#### IV. REMARKS

Applicant is appreciative of the Examiner's finding of allowable subject matter as stated on page 6 of the Office Action mailed June 11, 2004. Claims 16 and 19 have been rewritten in independent form including all of the limitations of the base claim and any intervening claims and are now new claims 21 and 22 herein.

# Annotated Marked-up Drawing

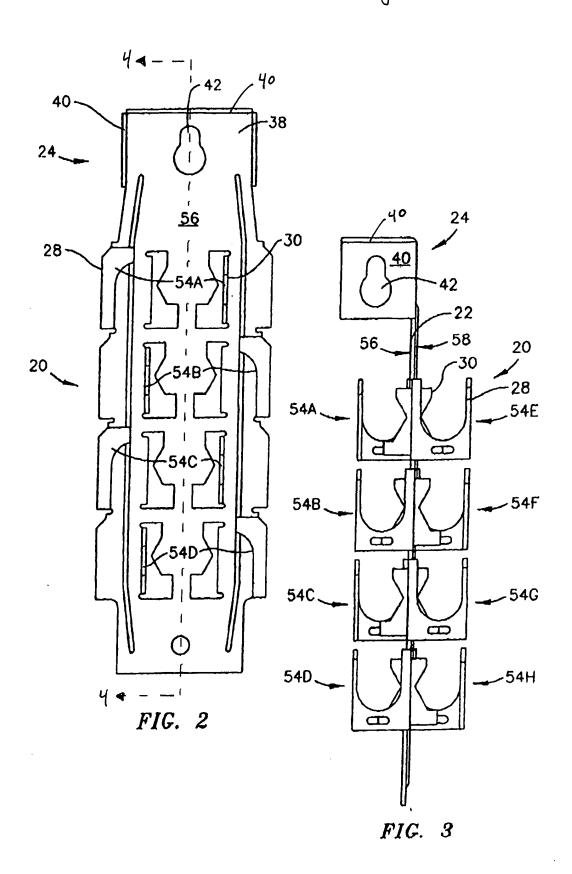
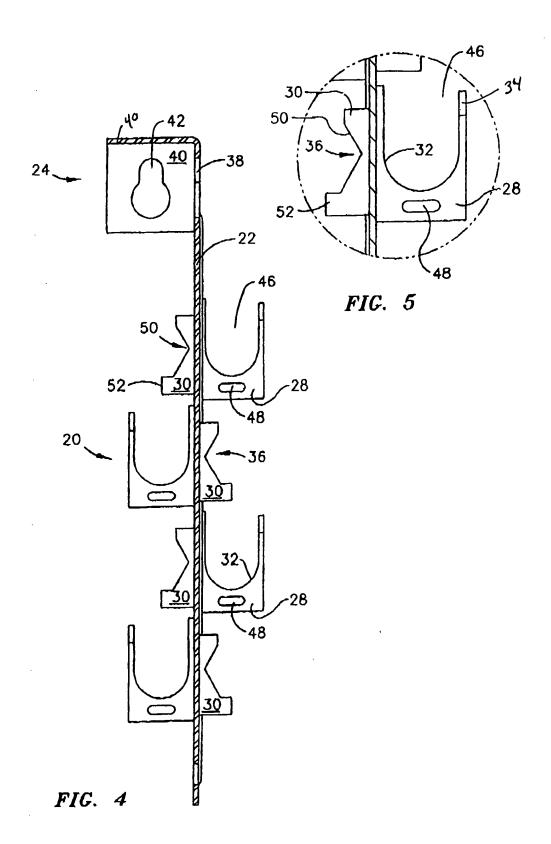
The Examiner states on page 4 of the Office Action that the three ears extending from each side of the head in claim 4 must be shown or the features canceled from the claims.

The Examiner further states on pages 4 and 5 that: it is unclear whether the word "on" in the above phrases means that the first holding member is made up of the arcuate cable holding member and the deformable member or whether the first holding member is a separate element. The Examiner further states that it is unclear where the arcuate cable holder begins and the deformable member ends.

Applicant has herein submitted replacement sheets for Fig. 1 (sheet 1 of drawings), Figs. 2 and 3 (sheet 2), Figs. 4 and 5 (sheet 3) and Fig. 6 (sheet 4). To understand the relationship of the three ears extending from each side of the head, the Examiner is referred to Fig. 6, which shows three ears 40 extending from the head 38. It is stated in the present application that "the bend lines are shown in broken lines on Fig. 1 and include the bend lines 68 for forming the head 38" (page 9, lines 3-4). Therefore, as shown in Figs. 1 and 6, there are three ears 40 and they extend from each side of the head 38 with the head 30 being the top portion of the base 22 (see Fig. 1) and the sides of the head 38 denoted by the bend lines 68 (see Fig. 1).

Applicant refers the Examiner to the plan view of a blank that will be formed into a cable holder in Fig. 1 and the perspective view of the cable holder in Fig. 6 for a clarification on the details of the first holding member 28. As stated in the application "the first holding member 28 typically extends at a 90 degree angle from the base 22 and includes a deformable member 34 extending at an angle of 90 degrees from the first holding member 28. The arcuate cable holder 32 is an open area in the first holding member 28 that includes between 260 and 280 degrees of arc of a full circle. The deformable member 34 extends from the first holding member 28 at a point between 155 and 165 degrees of said arc away from the base 22" (page 7, lines 9-14). As shown in Fig. 1, the arcuate cable holder 32 extends between 260 and 280 degrees of arc around the inner periphery of the first holding member 28. The deformable member 34 extends from the first holding member 28 at between 155 and 165 degrees of the arc. The arc of the arcuate cable holder 32 begins at the portion of the inner periphery of the first cable holder 28 along the side adjacent the base 22 and extends therefrom to the opposite end. After the blank has been bent along the bend lines (shown in dashed lines in Fig. 1) to form the first cable holder 28 at a 90 degree angle to the base 22 and the deformable member 34 at a 90 degree angle to the remainder of the first holding member 28 as shown in fig. 6, the arcuate cable holder 32 includes a total arc of between 260 and 280

degrees of arc of which 155 to 165 degrees of arc are in a plane perpendicular to the base 22 and the remainder of the arc are in a plane parallel to the base 22. As further stated in the application "a screwdriver or similar leverage tool (not shown) is then inserted into the slot 48 in the first holding member 28. Pressure is then exerted on the first holding member 28 until the deformable member 34 secures the cable 78 against the base 22. Exerting pressure on the slot 48 causes the first holding member 28 to buckle or bend in the vicinity of the slot 48 and thereby collapse the channel 46. The deformable member 34, being integral with the base 22 and constructed of steel, deforms against the cable 78 and secures it against the base 22. The screwdriver is then removed from the slot 48 and the deformable member 34 retains its deformed shape, thereby trapping the cable 78 against the base 22" (page 9, lines 12-20). The arcuate cable holder 32 therefore includes the entire arcuate inner periphery of the first cable holder 28 and the deformable member 34 includes the outer portion of the first cable holder 28 beginning at 155 to 165 degrees of arc from the start of the arcuate cable holder 28 adjacent the base 22.
